PLANNING BOARD REPORT
PORTLAND, MAINE
977 Brighton Avenue
Senior Housing
Level III Site Plan and Subdivision Plan
2017-299
Applicant: Avesta Housing

Submitted to Portland Planning Board Public Hearing Date: July 24, 2018	Prepared by: Christian Roadman Date: July 20, 2018
--	---

Western elevation of proposed 977 Brighton Project (image: provided by applicant)

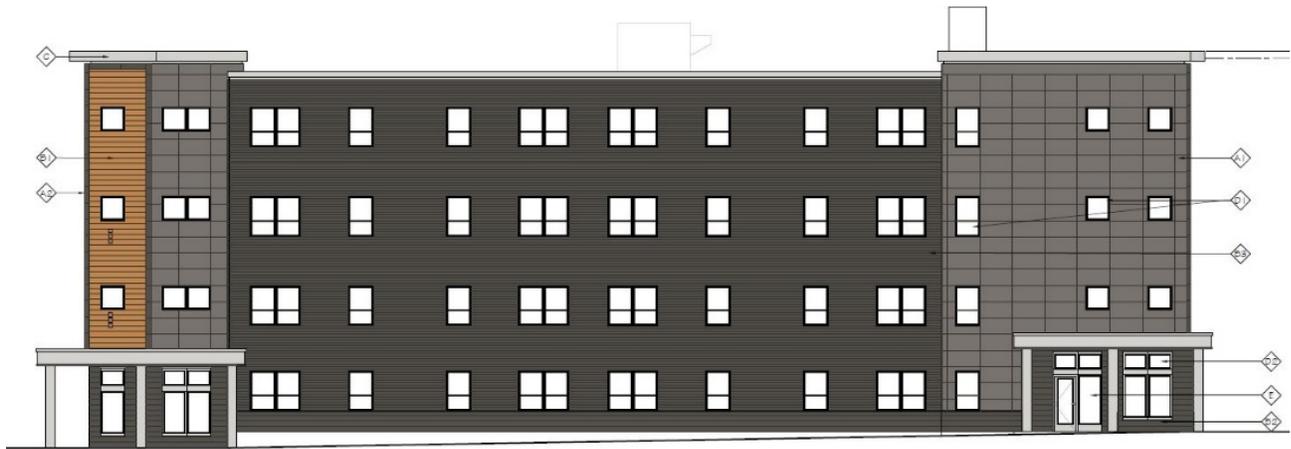
Caitlin Cameron, Urban Designer, provided review comments (attachment 7) responding to the applicant's updated designs:

- Revisions submitted 7/18/18 – comments revised to reflect final design
- Overall supportive of the scale, massing, and height of the project for this context and street
- *Concern about the durability of fiber cement material at the ground – consider a base with a more durable material*
- *Prefer seating added to the site; landscape between inactive portions of building and street.*
- *Landscape design could enhance the less active portions of the buildings such as the stair towers*
